**CCL 29/06/21 - APPROVAL OF STAGING PLAN FOR BLACK HILL
EMPLOYMENT LANDS**

Staging Plan

Industrial Subdivision

Lot 30 in DP 870411 known as 198 Lenaghans Drive, Black Hill – City of Newcastle

ITEM-57 **Attachment B:** Indicative Lot Layout and Staging Plan

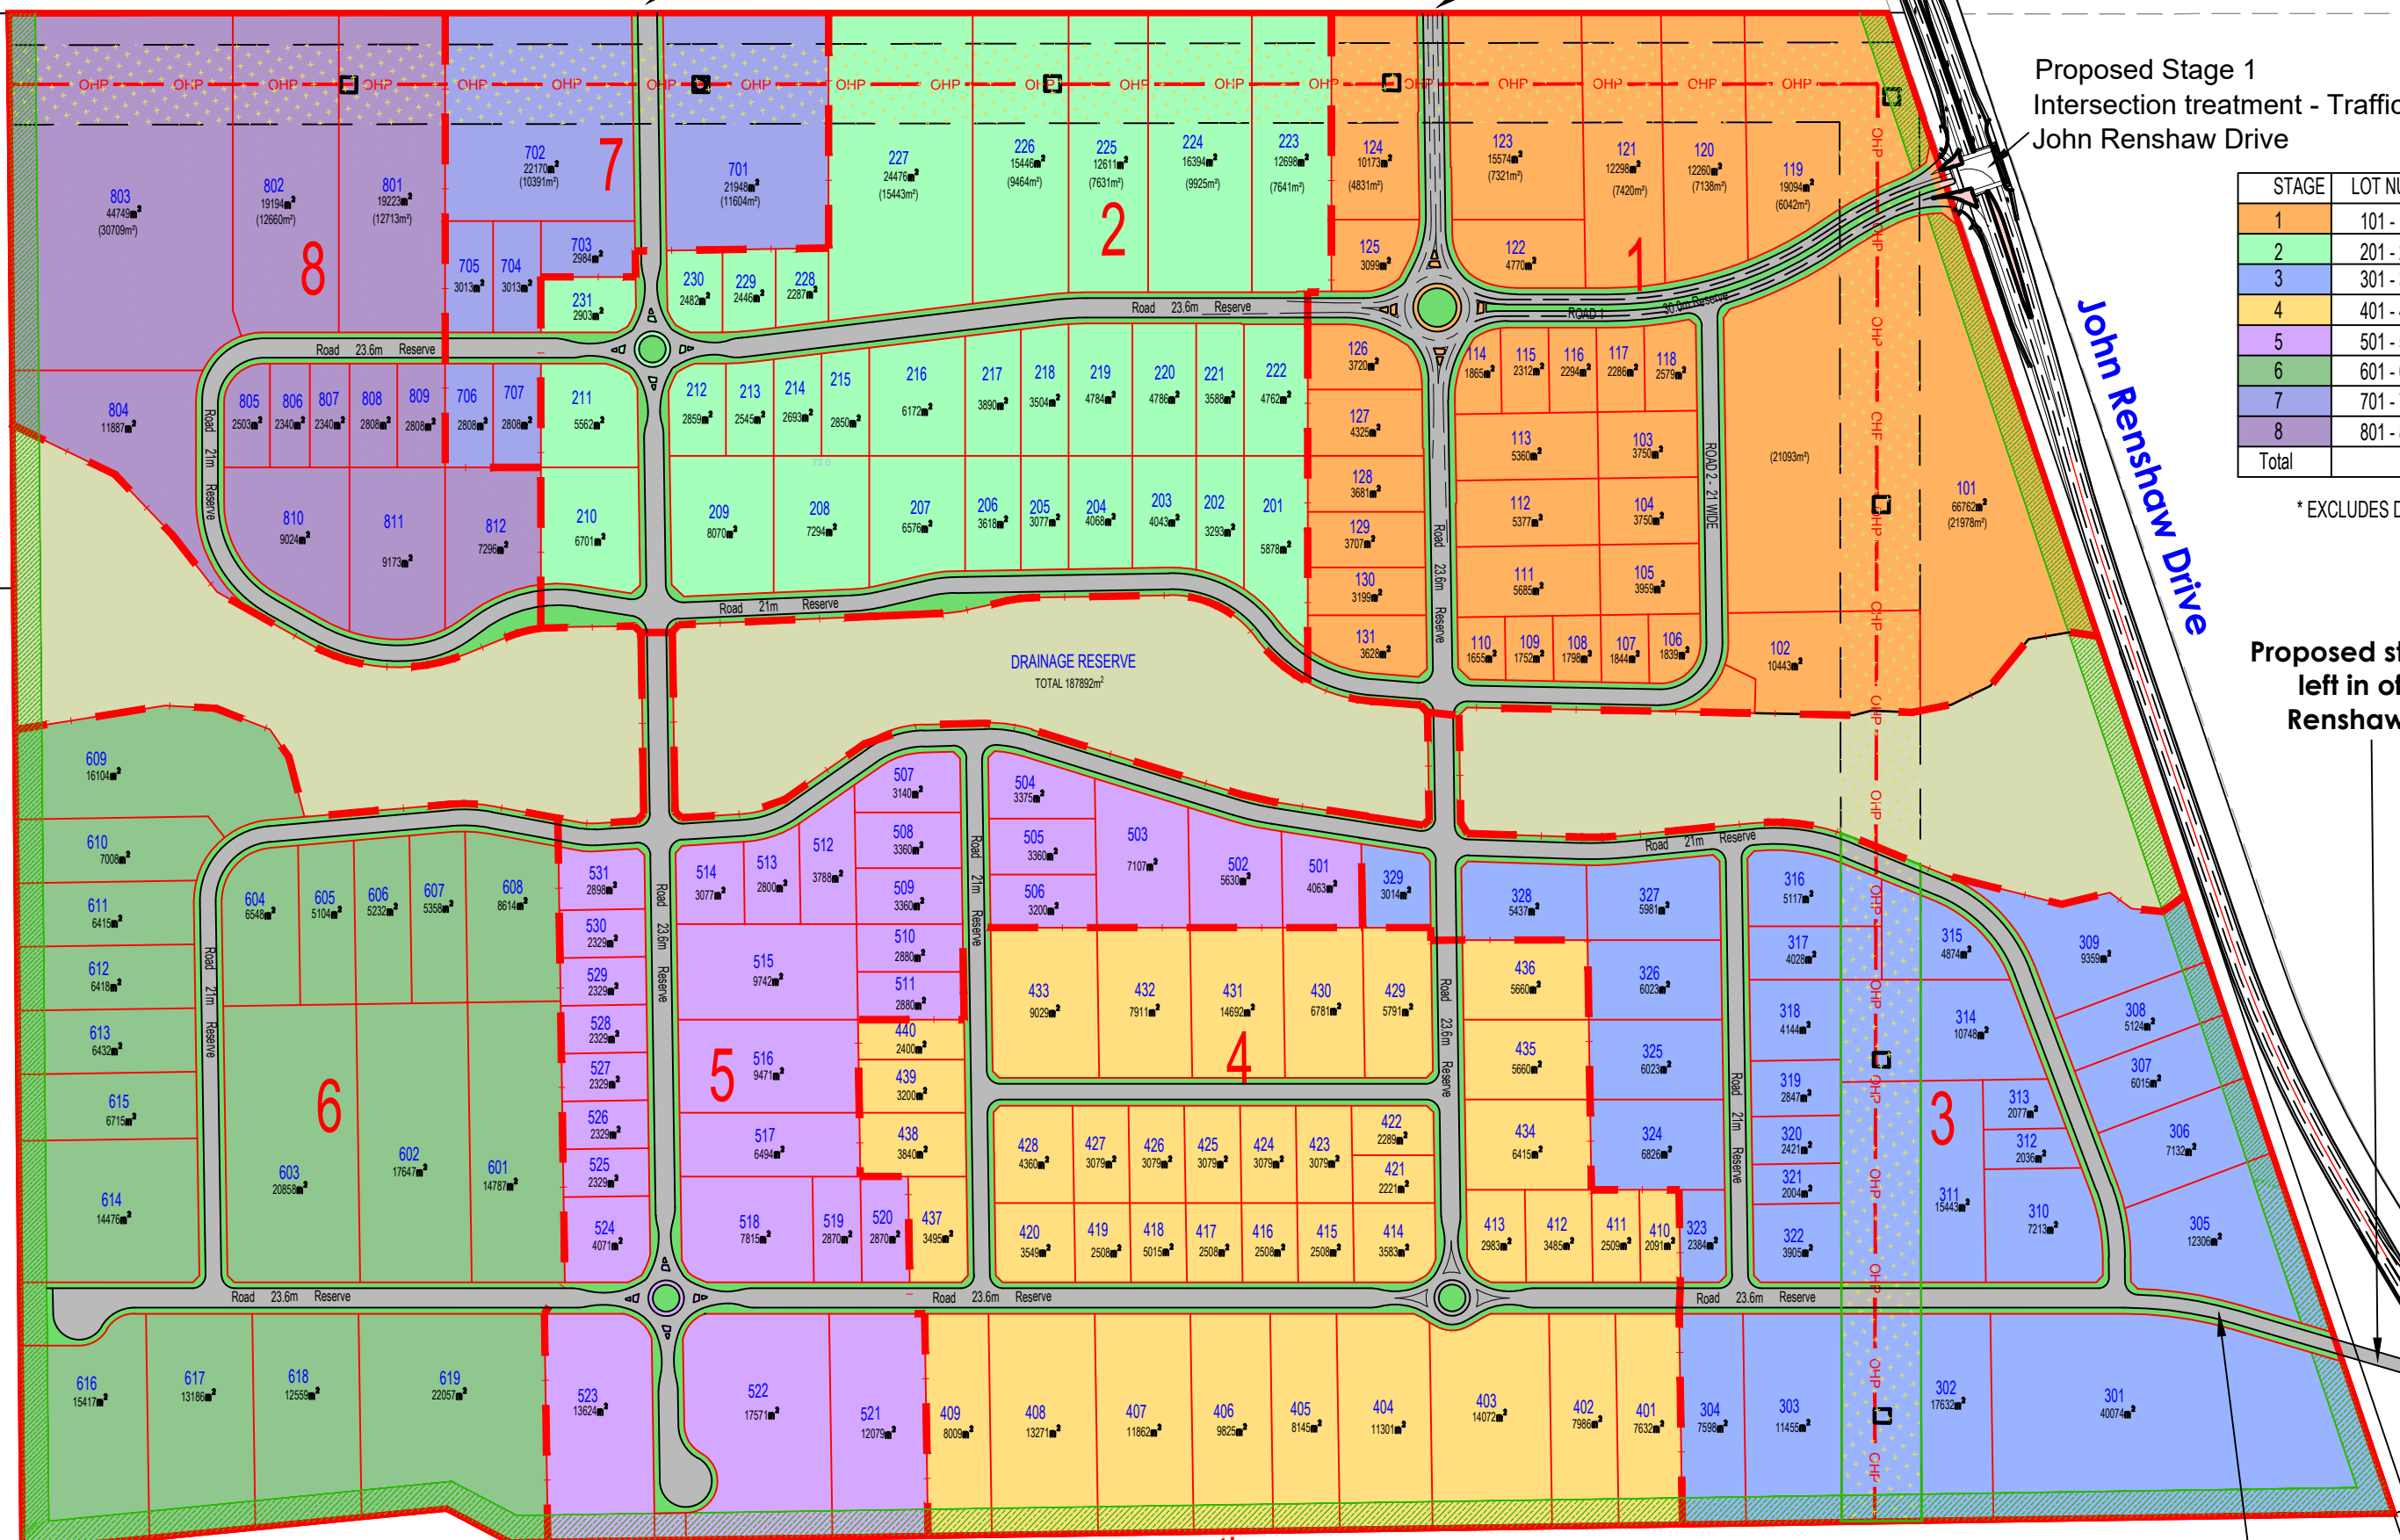
Public Exhibition: 30 November 2020 until 18 January 2021		
Submission Number	Points raised in submission	Response
1	<ul style="list-style-type: none"> Transport for NSW (TfNSW) raised no objection subject to comments and meeting all the requirements otherwise provided within the Part 3A Concept Plan Approval. TfNSW notes that no masterplan for the catalyst area has been undertaken in accordance with the Greater Newcastle Metropolitan Plan 2036 action and recommend both the City of Newcastle and Cessnock Council work towards developing a site masterplan with TfNSW. TfNSW advised that the Black Hill Traffic Modelling report by SMEC dated October 2020, prepared on behalf of TfNSW is to form the basis of assessing the traffic related impacts for all development applications within the Black Hill precinct. Recognises the site has the benefit of a Concept Approval, which includes provision for a left in/ left out intersection to the Pacific Motorway and a signalised intersection wholly located on the land, located on the western site boundary. Future consideration of the left in-left out intersection will be subject to TfNSW agreement. Raised no objection in principle to the relocation of the signalised intersection from the western site boundary to 225 metres east of the western site boundary. In the absence of a precinct masterplan it is recommended the City of Newcastle consult with Cessnock Council regarding potential connections between this site and the Broaden site. 	<ul style="list-style-type: none"> Noted The Black Hill Employment Lands site within the Newcastle local government area is covered under an existing Concept Approval (approved November 2013), with accompanying Urban Design Guidelines that have been endorsed by the Secretary for the Department of Planning and Environment in 2018. The preparation of an Indicative Lot Layout and Staging Plan is a requirement of the Concept Approval, there is no requirement for this Plan to be consistent with other Government Strategies or plans, including the Greater Newcastle Metro Plan. Noted. Noted. Further clarification was sought by Council regarding TfNSW position on the left in/left out intersection. See summary of additional TfNSW correspondence. Noted The Indicative Lot Layout and Staging Plan has been amended to include one of the proposed east west connections in Stage 1 rather than Stage 2, to ensure developments in Cessnock have early access to the proposed signalised intersection.

<ul style="list-style-type: none"> • The proposed layout undermines the development of the precinct. • The proposed lot layout is inconsistent with the broad control principles in regard to traffic and transport management for the site which were considered for the concept plan. • The proposed lot layout is not generally consistent with the concept approval and is not generally in accordance with the lot layout shown in the approved concept plan. The access should be located to provide a common access to the precinct on the common boundary. • The proposed layout has not considered the adjoining DCP and will lead to traffic conflict and an inefficient road layout. The access should be located to provide a common access to the precinct on the common boundary. • The additional information required to support the provision of infrastructure and to support the staging plan must be prepared and publicly exhibited with the plan to demonstrate compliance with the concept plan. • To allow the precinct to be delivered effectively and to meet the objectives of the Newcastle Metro plan, the access should be an access on the common boundary to allow a common access to the precinct and to provide efficient provision of services to the precinct. • Joint access on the common boundary provides equitable access and provision of services. 	<ul style="list-style-type: none"> • As above. • Considerable concept engineering design and SIDRA modelling has been done to support the preferred location and TCS configuration which has been used by TfNSW to produce the recent micro-simulation modelling. TfNSW have advised that the Black Hill Traffic Modelling report by SMEC dated October 2020, prepared on behalf of TfNSW is to form the basis of assessing the traffic related impacts for all development applications within the Black Hill precinct. This modelling also assumed the location of the signalised intersection east of the common boundary and not as a shared access along the common boundary. • The Land and Environment Court (LEC) Commissioner for the Class 1 Appeal found that moving the signalised intersection to the location proposed under DA2018/00714 (consistent with the exhibited indicative lot layout and staging plan) was generally consistent with the approved Concept Plan. Additionally, the indicative lot layout presented as part of the concept plan is explicitly not approved as per Condition 1.7 of the Concept Approval. • The Cessnock DCP does not apply as the site is located in Newcastle local government area. Additionally, the site has the benefit of a Concept Approval with no requirement to be consistent with the Cessnock DCP. • Additional information has been provided to satisfy the Concept Approval requirements under Condition 1.10 and was not considered to warrant public exhibition. • The Black Hill Employment Lands site within the Newcastle local government area is covered under an existing Concept Approval (approved November 2013), with accompanying Urban Design Guidelines that have been endorsed by the Secretary for the Department of Planning and Environment in 2018. The preparation of an Indicative Lot Layout and Staging Plan is a requirement of the Concept Approval, there is no requirement for this Plan to be consistent with other Government Strategies or plans, including the Greater Newcastle Metro Plan. • Noted. However, access along the common boundary is not ultimately the best location from a road safety perspective and

TfNSW Additional Response to CN's Request for Clarification (sent 6 January 2021)		
Date of Response	Points raised in submission	Response
12/04/2021	<ul style="list-style-type: none"> Advises that to accommodate future strategic design requirements on John Renshaw Drive, it does not support the left-in/left-out intersection as currently proposed. Highlights that the Black Hill Traffic Modelling report prepared by SMEC and dated 9 October 2020 (SMEC report) identified the need for south-facing ramps to serve the precinct traffic. With the exact location of this connection currently undetermined, TfNSW recommends Council ensure an appropriate local road network is provided within the Plan that is capable accommodating any future local road connection from all directions i.e. South, West and East. The future local road connection within the development sites, irrespective of the chosen route option, should be designed to 	<ul style="list-style-type: none"> Noted. The current Indicative Lot Layout and Staging Plan (Ref. HD15-HD01 Revision 11 dated 20/04/2021) provides for a left in only off John Renshaw Drive. This reflects the changes identified by TfNSW to accommodate future strategic design requirements. Noted. The current Indicative Lot Layout and Staging Plan (Ref. HD15-HD01 Revision 11 dated 20/04/2021) has been amended to accommodate any future local road connections from all directions (i.e. South, West and East). The current Indicative Lot Layout and Staging Plan has been amended to ensure that potential future local road connections are

Targeted Stakeholder Notification: 27 April 2021 to 7 May 2021		
Submission Number	Points raised in submission	Response
1	<ul style="list-style-type: none"> Cessnock City Council reiterated their position that the westernmost access should be located at the common boundary for the reasons outlined in our previous submissions. While our position regarding the westernmost access to the Newcastle site has not changed; above all else, it is essential that the final location of the access offers an appropriate level of certainty to the developer of the Cessnock land and does not significantly impact the timing, lot yield, subdivision layout or development costs associated with developing the Cessnock land. 	<ul style="list-style-type: none"> Noted. The subject site has the benefit of a Concept Approval and can develop the land in a manner provided it is generally consistent with the terms of approval, pursuant to Clause 3B(2)(d) of Schedule 2 of the <i>Environmental Planning and Assessment (Savings, Transitional and Other Provisions) Regulation 2017</i>. The Land and Environment Court (LEC) Commissioner for the Class 1 Appeal found that moving the signalised intersection to the location proposed under DA2018/00714 (consistent with the exhibited indicative lot layout and staging plan) was generally consistent with the approved Concept Plan. The access location shown on the current Indicative Lot Layout and Staging Plan (Ref. HD15-HD01 Revision 11 dated 20/04/2021) reflects the changes identified by TfNSW to accommodate future strategic design requirements. As per the above principle, this location is considered consistent with the Concept Approval. The land at 337 Blackhill Rd, Black Hill (also known as 1134 John Renshaw Dr, Black Hill) already has allowance for one 'all direction' traffic signal controlled (TCS) located at the western access and co-located with the entrance road to the mine opposite. The preference by the developer to not commence their proposed development at the western TCS is a commercial decision. The Cessnock site will also be provided with an east west connection proposed under Stage 1 of the Indicative Lot Layout and Staging Plan, allowing developments in Cessnock access to the proposed signalised intersection upon completion of Stage 1. Furthermore, there is nothing that precludes the opportunity for adjoining site to seek approval from TfNSW for an additional access with John Renshaw Drive.

2	<ul style="list-style-type: none"> The location of the access further limits the opportunity for the access to be provided for the adjoining property in line with the Cessnock DCP. The plan shows the acceleration and deceleration lanes have a significant impact on the opportunity to gain access to the adjoining site to the west in line with the Cessnock DCP. 	<ul style="list-style-type: none"> Noted. The site has the benefit of a Concept Approval with no requirement to be consistent with or facilitate the outcomes identified in the Cessnock DCP. The current Indicative Lot Layout and Staging Plan (Ref. HD15-HD01 Revision 11 dated 20/04/2021) reflects the changes identified by TfNSW to accommodate future strategic design requirements.

<ul style="list-style-type: none"> • The location of this proposed intersection should be modelled with the other identified locations along John Renshaw Drive, including one on the common boundary in line with the DCP and the western access into the Broaden site. • We are also concerned about the certainty of any internal access being provided based on the proposal not being consistent with the concept plan and this raises concerns that the 34A certificate for biodiversity may not be valid and again raises the uncertainty about the plan being inconsistent with the Concept Plan, which is required under the Environmental Planning and Assessment Act. 	<ul style="list-style-type: none"> • TfNSW advised both parties that the Black Hill Traffic Modelling report by SMEC dated October 2020, prepared on behalf of TfNSW is to form the basis of assessing the traffic related impacts for all development applications within the Black Hill precinct. The current Indicative Lot Layout and Staging Plan (including signalised intersection location) reflects the changes identified by TfNSW to accommodate future strategic design requirements for the area. Furthermore, there is nothing that precludes the opportunity for Broaden site to undertake this modelling and seek an additional access with John Renshaw Drive. • The LEC Commissioner for the Class 1 Appeal found that moving the signalised intersection to the location proposed under DA2018/00714 was generally consistent with the approved Concept Plan. Additionally, the indicative lot layout presented as part of the concept plan is explicitly not approved as per Condition 1.7 of the Concept Approval. This process to approve a Staging Plan seeks to formalise the concept plan as required by the conditions of approval, principally 1.10.

<ul style="list-style-type: none"> No direct access shall be provided between the development and John Renshaw Drive or the M1 Pacific Motorway, other than provided by the proposed public local road network. 	<ul style="list-style-type: none"> Access to each allotment is provided by the proposed public local road network as outlined on the indicative lot layout and staging plan, with no direct access of allotments to John Renshaw Drive or the M1 Pacific Motorway specified. This stipulation also forms part of the approved Urban Design Guidelines.
2	<ul style="list-style-type: none"> Cessnock City Council (CCC) objects to the proposed indicative lot layout and staging plan as the exhibited material nominates alternate access contrary to the shared boundary access. This position regarding the location of the shared (westernmost) access has remained consistent since the initial lodgement of the Planning Proposal for the Cessnock site on 7 March 2012. This has been previously expressed during consideration of Newcastle City Council's deemed refusal of Development Application No. DA 2018/714 for a 200 lot Torrens title subdivision at 198 Lenaghans Drive, Black Hill. A shared access at the common boundary of the sites was (and still is) considered a logical and cost effective servicing approach to integrate both sites and reducing the need for four separate intersections onto John Renshaw Drive to three. The shared boundary access is considered an equitable outcome that permits both developers to progress independently of one another, while minimising the requirement and extent of easements, reciprocal rights-of-way, etc. that will be required between the two industrial sites. Shared access at the common boundary of the sites will ensure one developer is not overly burdened by the other's development timeframes, or by additional road construction costs and extensions to connect the two sites. Removal of shared access will not offer an appropriate level of certainty to the developer of the Cessnock land and will significantly impact the timing, lot yield, subdivision layout, development costs and, ultimately, employment outcomes associated with the Cessnock land. The location of the westernmost access is inconsistent with Concept Structure Plan for the Cessnock site, as outlined in the Cessnock Development Control Plan (DCP), adopted on 17 April 2019. The DCP prioritises the location of the joint access along the shared boundary between the Cessnock and the Newcastle sites. 	<ul style="list-style-type: none"> Noted. The land at 337 Blackhill Rd, Black Hill (also known as 1134 John Renshaw Dr, Black Hill) already has allowance for one 'all direction' traffic signal controlled (TCS) located at the western access and co-located with the entrance road to the mine opposite. The preference by the developer to not commence their proposed development at the western TCS is a commercial decision. As above. The Cessnock DCP does not apply as the site is located in Newcastle local government area. Additionally, the site has the benefit of a Concept Approval with no requirement to be consistent with the Cessnock DCP.

<ul style="list-style-type: none"> The adjoining site requires stage 1 to commence in the north east corner, which is adjacent to the subject site. This is being done to gain access to services, such as sewer and electricity, to be consistent with existing planning documents and to provide a single combined access to the precinct. The proposed access through the subject site will place the adjoining site at a significant disadvantage and will delay the coordinated development of the whole precinct. Requests Council not to support the location of the access and insist that the access be placed in a location that is consistent with the concept plan. The access should be a common access to best serve the precinct which is on the common boundary. 	<p>entrance road to the mine opposite. The preference by the developer to not commence their proposed development at the western TCS is a commercial decision.</p> <ul style="list-style-type: none"> As above. The subject site has the benefit of a Concept Approval and can develop the land in a manner provided it is generally consistent with the terms of approval, pursuant to Clause 3B(2)(d) of Schedule 2 of the <i>Environmental Planning and Assessment (Savings, Transitional and Other Provisions) Regulation 2017</i>. The Land and Environment Court (LEC) Commissioner for the Class 1 Appeal found that moving the signalised intersection to the location proposed under DA2018/00714 (consistent with the exhibited indicative lot layout and staging plan) was generally consistent with the approved Concept Plan.

<p>cater for a minimum two-way traffic volume of approximately 900 vehicles/hour and a minimum peak direction (one-way) traffic volume of approximately 700 vehicles/hour during AM and PM peak hours. This estimation is based on the Developments' Travel Patterns included within the SMEC report.</p> <ul style="list-style-type: none"> • No objections raised to any new internal roundabout/s Council may consider necessary to appropriately service a future local road connection. • Understands the following changes are intended to be implemented to the Indicative Lot Layout and Staging Plan to accommodate future strategic design requirements on John Renshaw Drive: <ul style="list-style-type: none"> ○ Relocate proposed western signalised intersection approximately 80m west of the current proposed location (225m east of the western Stevens site boundary) i.e. the proposed western signalised intersection to be approximately 145m east of the western Stevens site boundary. ○ Remove proposed left-in/left-out intersection (350m west of the M1 Pacific Motorway/Weakleys Drive/John Renshaw Drive signalised intersection) and provide a left-in only intersection approximately 200m east of the current proposed location i.e. the new left-in only intersection to be approximately 150m west of the M1 Pacific Motorway/ Weakleys Drive/John Renshaw Drive signalised intersection. ○ Extend proposed 23.6m road reserve through Lot 523 and Lot 524 to create a stub road up to the vegetation buffer. • Proponent agreed during consultation to make further changes to the internal lot and road layout, if necessary, in future development applications to accommodate preferred local road connection to the south-facing ramps that is yet to be determined. • Highlights that the detailed design of the western signalised intersection is subject to separate further design review in accordance with the Concept Plan approval. • Requests a notation be included within any final indicative lot layout and staging plan outlining that the purpose is not to identify off-site mitigation road works and traffic and transport impacts will be reviewed as part of future Development Applications (DA) on the site. 	<p>planned with appropriate dimensions to serve as industrial collector roads.</p> <ul style="list-style-type: none"> • Noted. • Noted. The current Indicative Lot Layout and Staging Plan (Ref. HD15-HD01 Revision 11 dated 20/04/2021) reflects the changes identified by TfNSW to accommodate future strategic design requirements. • Noted. CN supports flexible approach to achieve appropriate outcomes. • Noted. • Noted. This is acknowledged in the Staging Plan (April 2021), prepared by Tibor Kovats Consulting.

<ul style="list-style-type: none"> • We are not aware of modelling to support this position, as required by the concept plan. • The 34A certificate was issued on the basis that the development application is or will be made in accordance with the concept plan. As this application has not been made in accordance with the concept plan, this raises uncertainty as to whether the development can proceed, and the internal access would ever be provided to the adjoining land. We note that no ecological assessment has been undertaken with the existing development application before council. • We again reiterate that the application is not consistent with the approved concept plan and urban design guidelines, the road has not been proposed on the common boundary providing access and frontage to the adjoining property as is shown in the Concept Plan. • No information has been provided in relation to the suitable sight distances for the location of the proposed intersection. Previously TfNSW had identified that the location to the east of the currently proposed access point was identified as an acceptable location as was the access located on the common boundary by the Concept Plan. The road has a crest to the east of the location that will affect sight distance, there is no evidence to show that this has been considered. • This submission must be read together with our first submission. • We raise the strongest objection to the location of the access. 	<ul style="list-style-type: none"> • On 29 October 2020, TfNSW held a joint meeting with representatives in respect to the proposed developments at 198 Lenaghans Drive and 337 Blackhill Rd (also known as 1134 John Renshaw Dr), Black Hill. Together these sites form the Emerging Black Hill Precinct. TfNSW advised both parties that the Black Hill Traffic Modelling report by SMEC dated October 2020, prepared on behalf of TfNSW is to form the basis of assessing the traffic related impacts for all development applications within the Black Hill precinct. • The Concept Approval includes a number of conditions that are required to be satisfied prior to the first application for subdivision. Specifically Condition 1.10, that stipulates the proponent prepare a staging plan for Council's approval. The plan must provide for an updated indicative lot layout, identifying how the development of the site would be staged under 1.10(a) as the indicative lot layout presented as part of the concept plan is explicitly not approved as per Condition 1.7 of the Concept Approval. This process is formalising the concept plan as required by the conditions of approval. This does not yet involve or relate to applications for development. Furthermore, Condition 1.10 of the Concept Approval does not require an ecological assessment to be undertaken to inform the Staging Plan. • The LEC Commissioner for the Class 1 Appeal found that moving the signalised intersection away from the western boundary to the location proposed under DA2018/00714 was generally consistent with the approved Concept Plan. Additionally, the indicative lot layout presented as part of the concept plan is explicitly not approved as per Condition 1.7 of the Concept Approval. • No concerns were identified by TfNSW when sight distances for this intersection location were raised by CN in a meeting held on 08/04/2021. Furthermore, the current Indicative Lot Layout and Staging Plan (Ref. HD15-HD01 Revision 11 dated 20/04/2021) reflects the changes identified by TfNSW to accommodate future strategic design requirements. • Noted. • Noted.
